Technical Note

Project No: ITB14679
Project Title: Land South of Ford Lane – Y/48/21
Title: Additional Information
Ref: DS/ITB14679-007
Date: 18 May 2021

Road Safety Audit Report

Proposed Temporary Priority Access to Meadow Gardens off North End Road Yapton

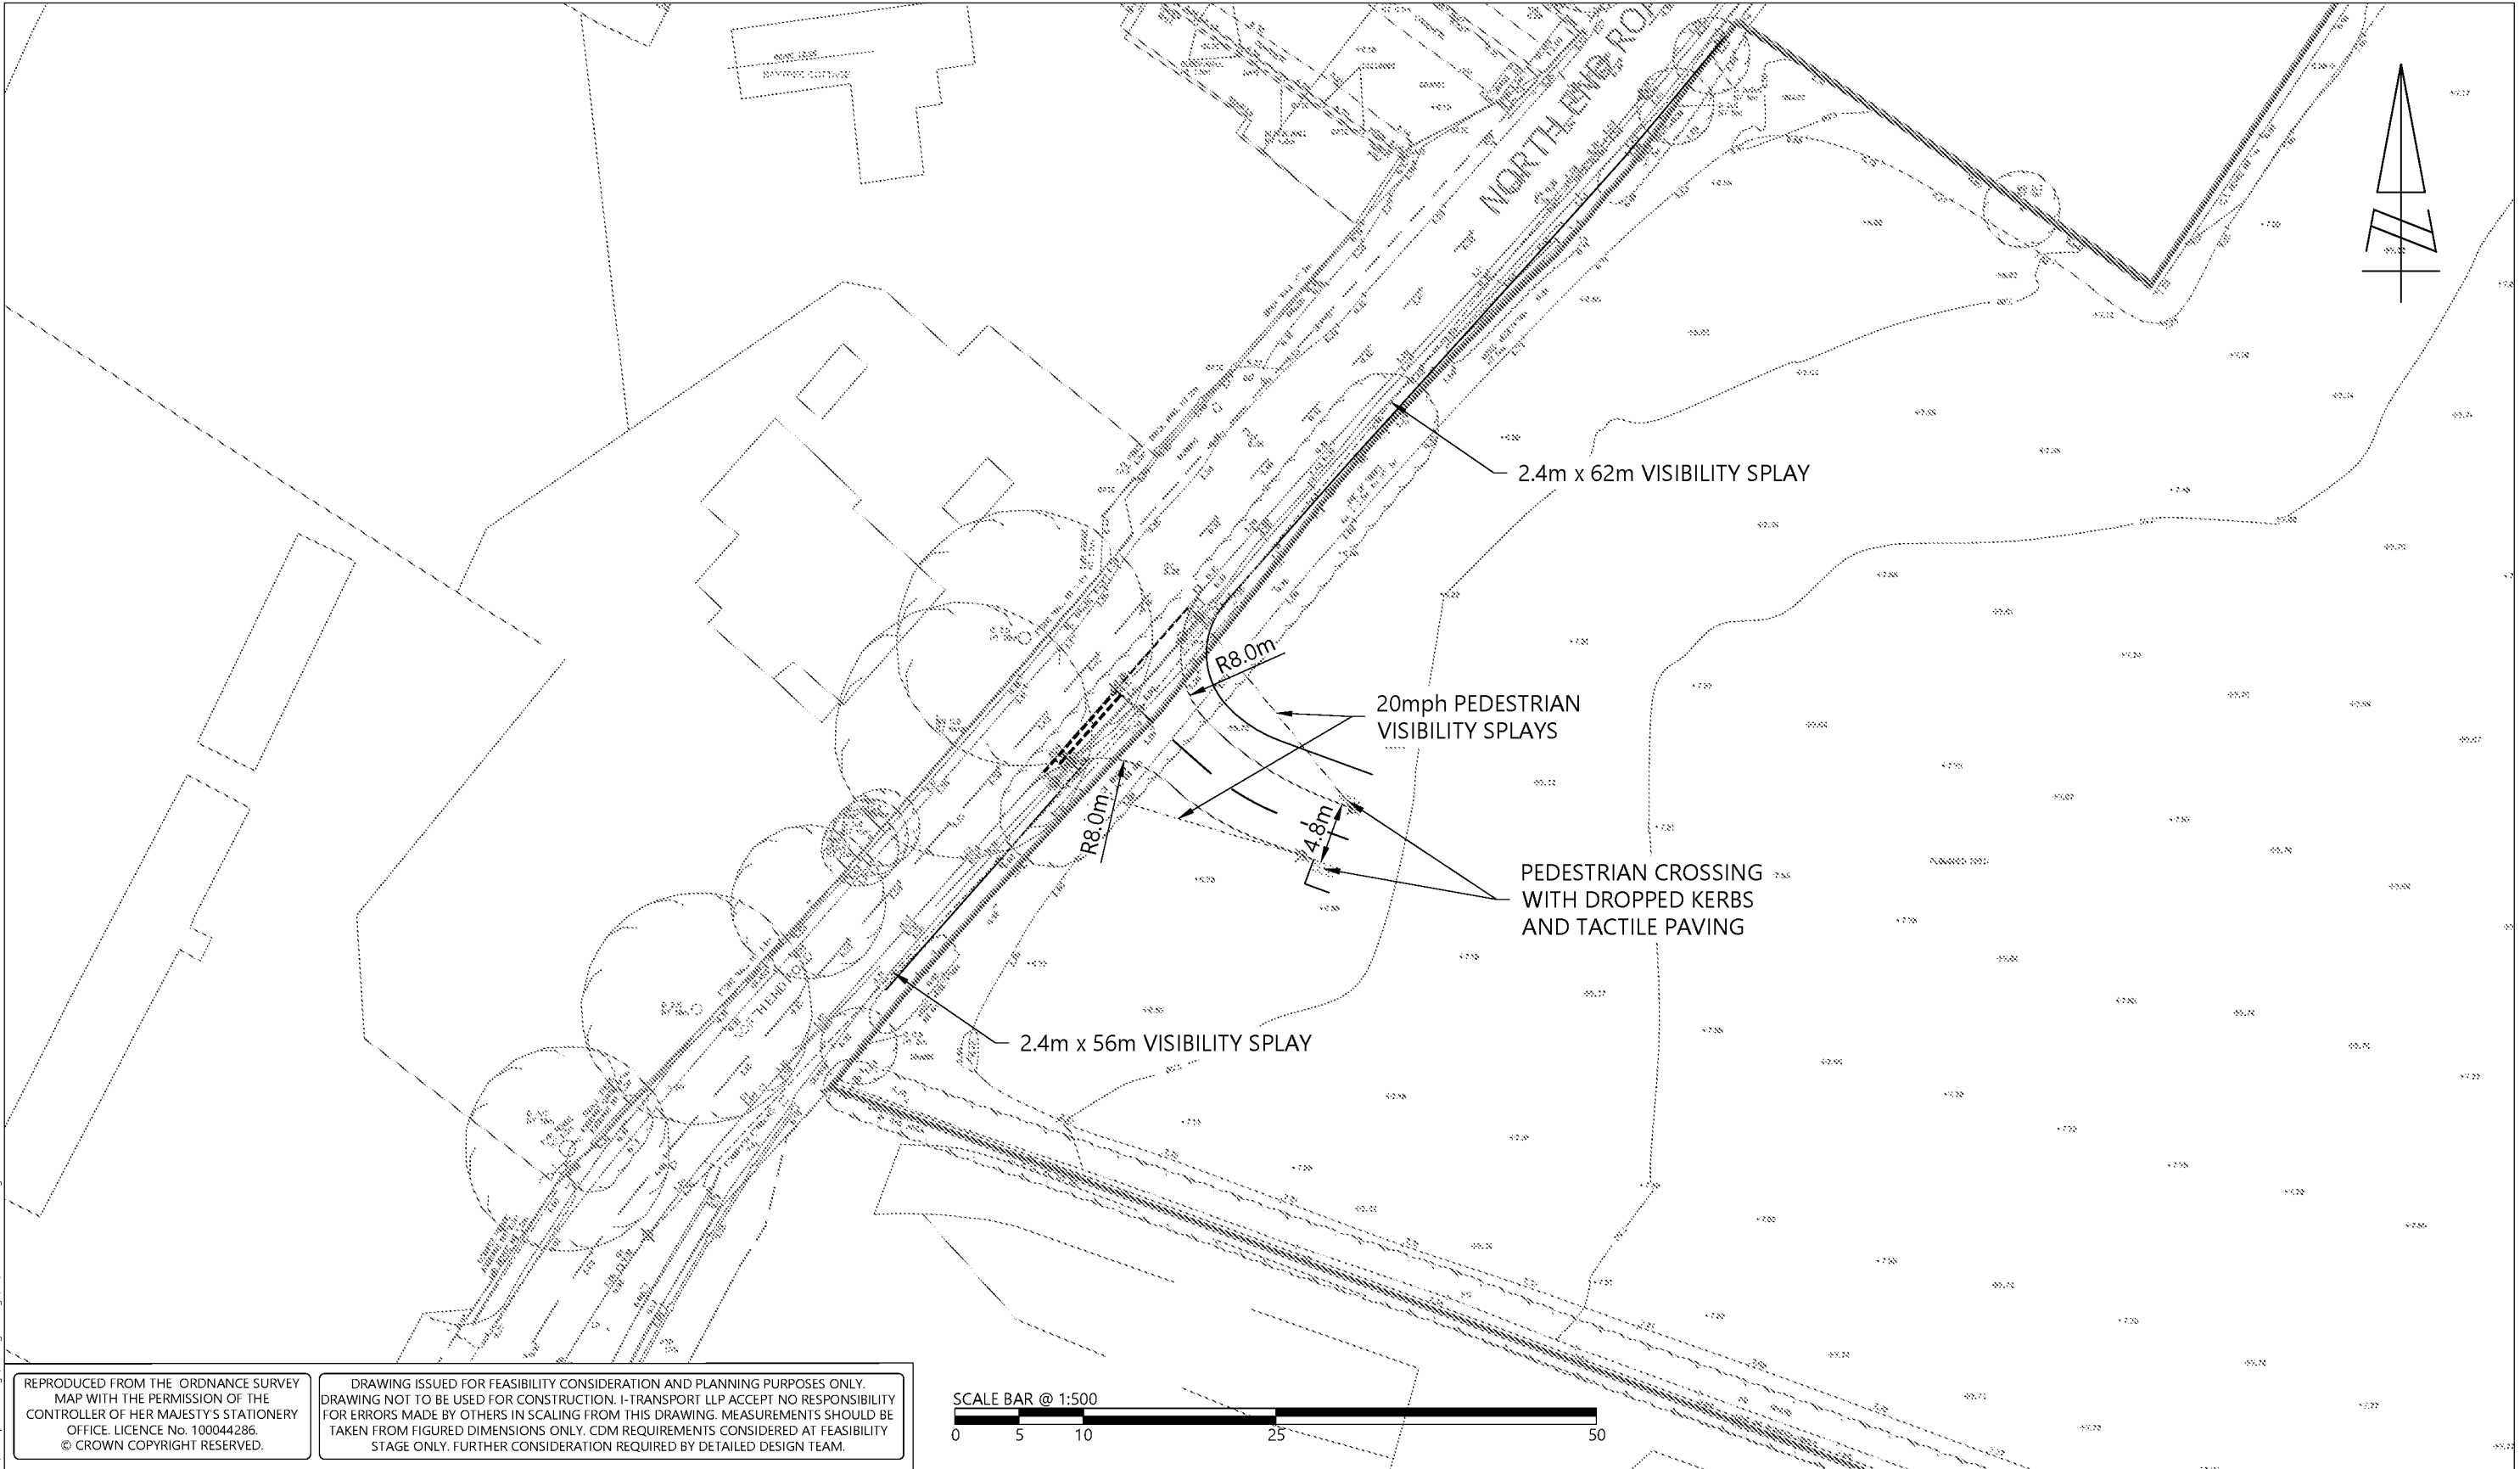
- A vehicle travelling northbound on North End Road being able to pass a refuse collection vehicle (RCV) turning left into the site;
- A refuse vehicle unexpectedly re-encroaching onto the opposing lane of the carriageway within the site after completing their initial access manoeuvre; and
- The provision of tactile paving should an internal crossing be provided.

2.3 All matters have been addressed in accordance with the recommendations of the Auditor. To accommodate the RCV turning into the site, the kerb radii has been increased to 8.0m on both side of the access junction and tracking is provided that demonstrates a northbound vehicle is able to pass.

2.4 To enable RCV access within the site without re-encroachment after completion of the access manoeuvre, some further tapering of the footway adjacent to the access road is allowed for to 'smooth' the alignment within the site. The footway is retained at a minimum width of 2.0m at all points.

2.5 The need for a pedestrian crossing point within the site is dependent on the build-out within the site and the point at which the temporary vehicular access is closed. Notwithstanding, tactile paving has been identified at the crossing should the crossing be formed.

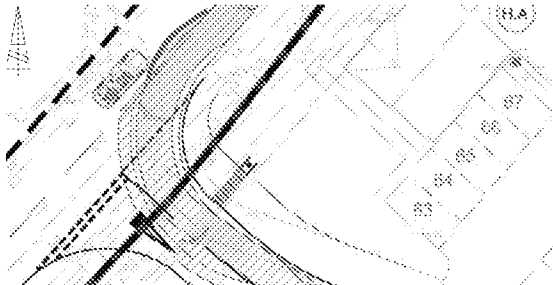
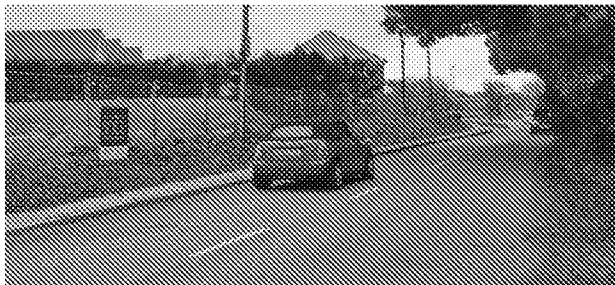
A.1	LOCAL ALIGNMENT
	<i>No Road Safety Concerns regarding LOCAL ALIGNMENT have been raised at this stage</i>
A.2	GENERAL
A.2.1	PROBLEM
Location:	North End Road
Summary:	The trailer of a refuse collection vehicle encroaches the opposing lane where one would not expect
Acc Type:	Sideswipes and loss of control
The B2132 North End Road forms a link between the A27 to the north and the B2233 to the south and is subject to a 30mph speed limit in proximity. The road serves a number of direct frontages as well as number priority access in the vicinity. As can be expected, refuse collection vehicles manoeuvre onto and off North End Road at various locations. The proposals subject to this Stage 1 Road Safety Audit include the provision of a temporary simple priority access off the western side of North End Road which accommodates a 6 metre entry radius. The scheme drawings provided with the Audit Brief, include a swept path of a refuse / recycling collection vehicle (RCV) turning left into the proposed access that illustrates the trailer of the vehicle swinging out into the opposing lane as well as encroaching the entire width of the access when undertaking the manoeuvre. Whilst the driver of a RCV will wait within the North End Road carriageway and not attempt to undertake the manoeuvre when a vehicle travelling along the access road approaching the give-way, a northbound vehicle would not expect the trailer of the RCV to swing out into their path when passing which could lead to sideswipe or loss of control type collisions.

RECOMMENDATION:	
It is recommended that a slacker inside corner radius is provided	
Location Plan:  	
DESIGN ORGANISATION RESPONSE provided by I-Transport on the 17 th May 2021 following formal issue of this Stage 1 Road Safety Audit on the 13 th May 2021	
Accepted – the swept path analysis has been adjusted and as illustrated on Dwg ITB14679-GA-003 Rev B to provide for a 8m radii on both sides of the access road. A RCV can turn left into the access road without the trailer encroaching the opposing lane to the extent that it would obstruct

oncoming traffic as shown in drawing ITB14679-GA-004. The vehicle encroaches the entire width of the proposed access road, however, this is common practice and the drivers of such vehicles do not commence their journey unless it is clear to do so.	
A.2.2	PROBLEM
Location:	Proposed access road
Summary:	Heavy goods vehicles encroach the opposing lane where one would not expect
Acc Type:	Sideswipes
The B2132 North End Road forms a link between the A27 to the north and the B2233 to the south and is subject to a 30mph speed limit in proximity. The proposals subject to this Stage 1 Road Safety Audit include the provision of a temporary simple priority access off the western side of North End Road that serves an access road that is 5.5 metres wide which reduces to 4.8 metres after circa 16 metres with a 20 metre inside radius. The scheme drawings provided with the Audit Brief, include a swept path of a refuse / recycling collection vehicle (RCV) turning into the proposed access that illustrates the vehicle encroaching the entire width of the access and part of the access road where the carriageway reduces, when undertaking the manoeuvre. Whilst the driver of a RCV will wait within the North End Road carriageway and not attempt to undertake the manoeuvre when a vehicle travelling along the access road approaching the give-way, the driver of a westbound vehicle is unlikely to expect the RCV to encroach their path at this location which could lead to sideswipe or loss of control type collisions.

Design Organisation Response

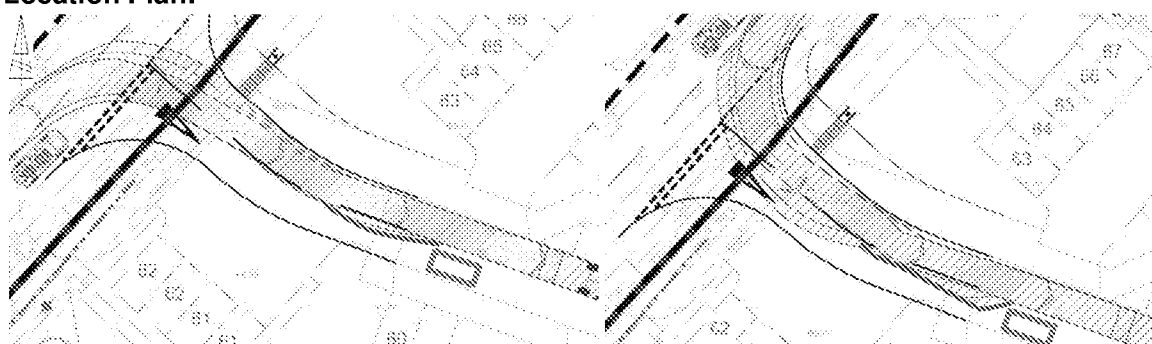
RECOMMENDATION:	
It is recommended that a slacker inside corner radius is provided	
Location Plan: 	
DESIGN ORGANISATION RESPONSE provided by i-Transport on the 12th May 2021 following formal issue of this Stage 1 Road Safety Audit on the 13th May 2021	
Accepted – the radii of the junction has been increased to 8m. The plan that was utilised for the swept path analysis included a 3.0 metre footway cycleway along the northern side which is to be retained as part of the permanent arrangements at this location; the width has been reduced to 2.0m for a short distance to accommodate the manoeuvre. As noted on the previous matter, the RCV does take up the entire width of the carriageway within the site, however, such movements are infrequent and a common occurrence in such locations across the local area. There is no

evidence such manoeuvres result in a highway safety issue. Within the site, the RCV does not cross then re-cross the centre line, a manoeuvre which may otherwise be unexpected.	
A.3	JUNCTIONS
	<i>No Road Safety Concerns regarding JUNCTIONS have been raised at this stage</i>
A.4	WALKING CYCLING AND HORSE RIDING
A.4.1	PROBLEM
Location:	Proposed access road
Summary:	No level access is provided for pedestrians to cross the proposed access road
Acc Type:	User trip and fall
The proposals that are subject to this Stage 1 Road Safety Audit includes the provision of a temporary simple priority access that is proposed to serve up to 16 dwellings and accommodates a 2.0 metre footway along the northern side. The scheme drawing provided with the Audit Brief, includes an illustration of a site layout with a 4.8 metre wide access road that benefits from a 2.0 metre footway both sides of the carriageway. The Audit Team is unaware if the illustration is the layout that will be in place for the temporary three year period when the proposed access is to be in use, however, no crossing point is provided to allow pedestrians level passage between the southern footway and northern footway that connects to the existing footway network which is highly likely to form a desire line.

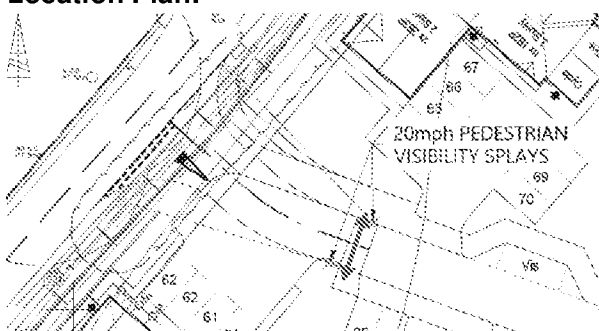
RECOMMENDATION:	
It is recommended that a dropped kerb crossing point with tactile paving is provided.	
Location Plan: 	
DESIGN ORGANISATION RESPONSE provided by i-Transport on the 12 th May 2021 following formal issue of this Stage 1 Road Safety Audit on the 13 th May 2021	
Accepted – the identified matter relates to the permanent layout of the site and therefore may not present during the lifetime of the temporary access. Notwithstanding, should footway be introduced on both sides of the access road while the access is in situ, a pedestrian crossing point will be provided as shown in drawing ITB14679-GA-003 Rev B.	
A.5	ROAD SIGNS, CARRIAGEWAY MARKINGS AND LIGHTING
	<i>No Road Safety Concerns regarding ROAD SIGNS, CARRIAGEWAY MARKINGS AND LIGHTING have been raised at this stage</i>
